Access Compliance Report Public Rights-of-Way (Curb Ramps)

Main Street: BLUME_DR Cross Street: CHRISTY_LN Location: SE

ADA ID: RPRK211216122013 Ramp Type: Type 1 - Perpendicular Diagonal Initial Pass/Fail: Pass Overall Compliance: No Severity Score: 12

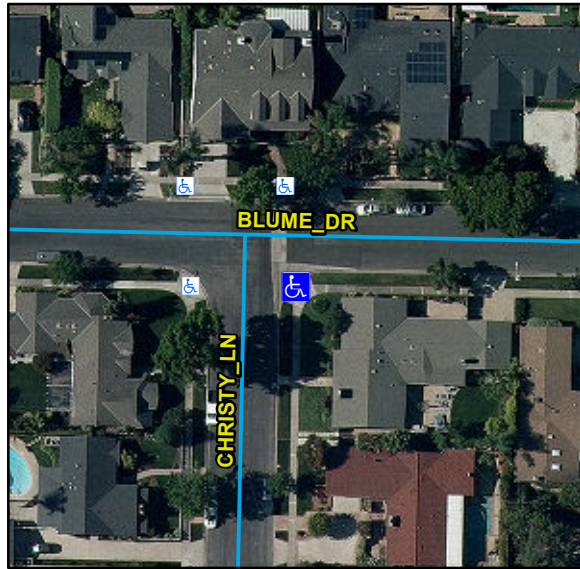
Remove & Replace Curb Ramp With Two New Directional Ramps or Equivalent. Gutter Ponding Observed.

N/A	Ramp Inside Crosswalk 1	N/A	Yes	Ramp Inside Crosswalk 2	N/A
	Crossing 1 Slope (%)	5.7		Crossing 2 Slope (%)	4.9
	Crossing 1 Cross Slope (%)	0.2		Crossing 2 Cross Slope (%)	0.4
No	Gutter Ponding	Yes	Yes	Curb Slope	1.5
Yes	Gutter Lip Height (in)	0		Road Run Slope (%)	0.2
Yes	Gutter Run Slope (%)	1.4		Road Cross Slope (%)	0
Yes	Gutter Cross Slope (%)	0			
Yes	Overall Surface Condition: Acceptable		No	Perp Joint Present	No
	Cross Gutter Present?	Yes		Spandrel Present?	Yes
	Replace Cross Gutter?	No		Replace Spandrel?	No

Possible Solutions:
